RE: Proposed Plan of Subdivision for the Hubble Subdivision to be located at 2379 Chemong Road, Township Selwyn, County of Peterborough.

Further to our recent meeting I have completed a review of the current draft plan (May 27, 2016) for the Hubble Subdivision to be located at 2379 Chemong Road. The review consisted of comparing this most recent plan (see attachment) to the plan that was the basis of the September, 2013 traffic report prepared by Tranplan Associates. This assessment also included a review of the 2013 traffic study report summarizing the traffic analyses and the geometric requirements for the proposed site entrance to Chemong Road. It is noted that the revised draft plan of subdivision is similar to the plan¹ that was the basis of the 2013 traffic report. The number of residential units remains the same at 24 single family dwellings. The general layout of these residential lots along a central spine road remains the same. Given that the study was completed in 2013 for a 2020 planning horizon, the study conclusions and recommendations should remain valid.

DRAFT PLAN OF PROPOSED SUBDIVISION

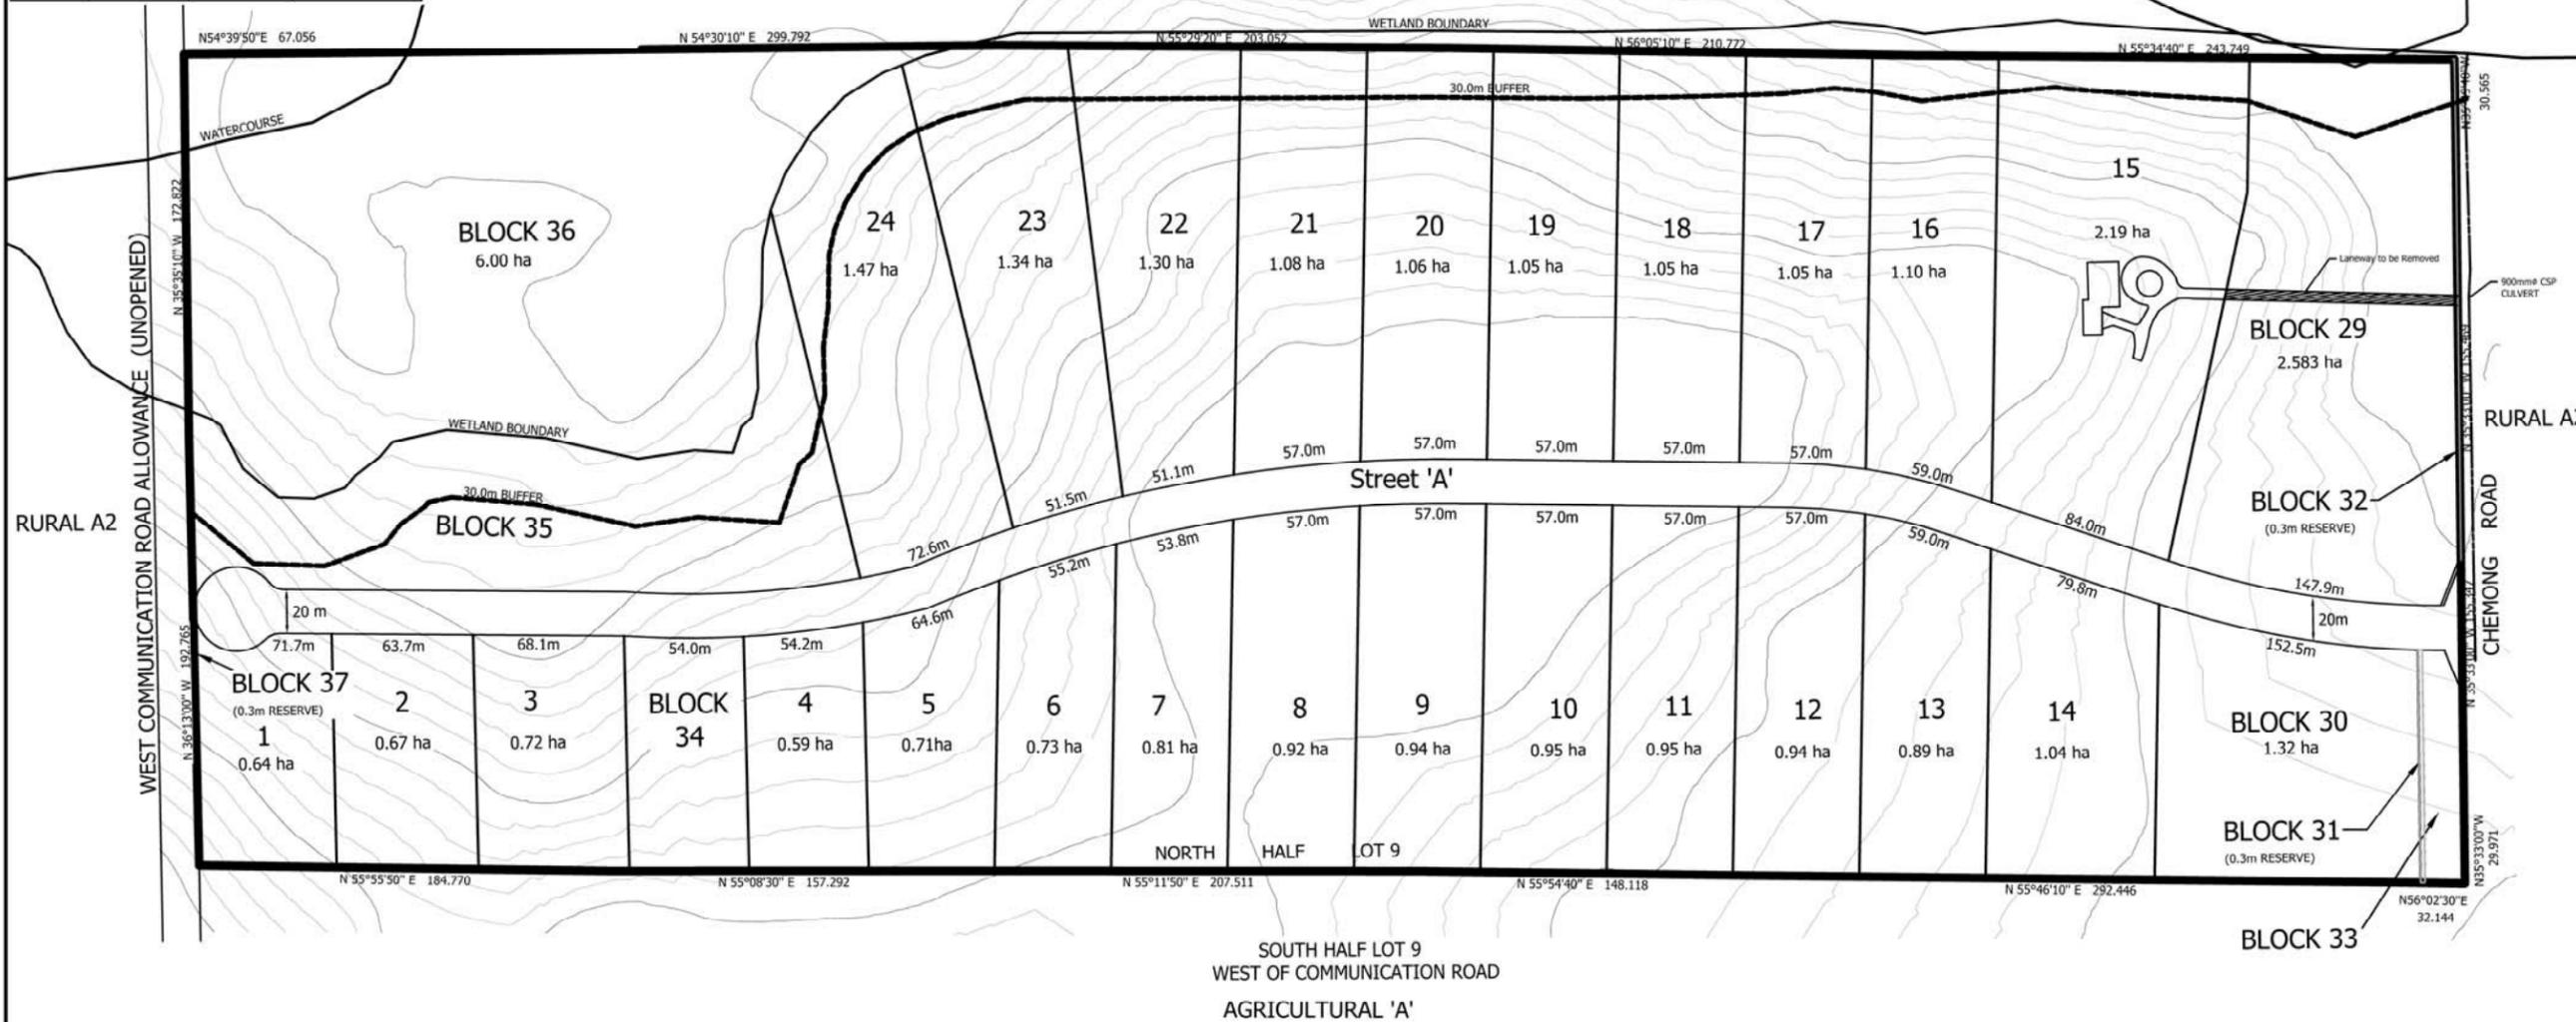
The 2013 draft plan showed two blocks fronting directly on Chemong Road. Discussions at the time suggested that they might be future commercial uses. However, since no definitive plans were in place, they were not considered in the study analyses. It is noted that in the current May 27, 2016 site plan, specific uses for these two blocks (# 29 and # 30) remain undefined. Since 2013 there has been further discussion on future commercial uses that might be located in these blocks. But no specific development plans are currently in place.

The 2013 traffic study assumed when plans for commercial uses in the two blocks fronting on Chemong Road were developed, an appropriate traffic study would be undertaken. This study would assess the traffic impacts of these uses at that time. This future update traffic study would define any necessary upgrades and/or mitigation measures that would be required at the site entrance intersection with Chemong Road.
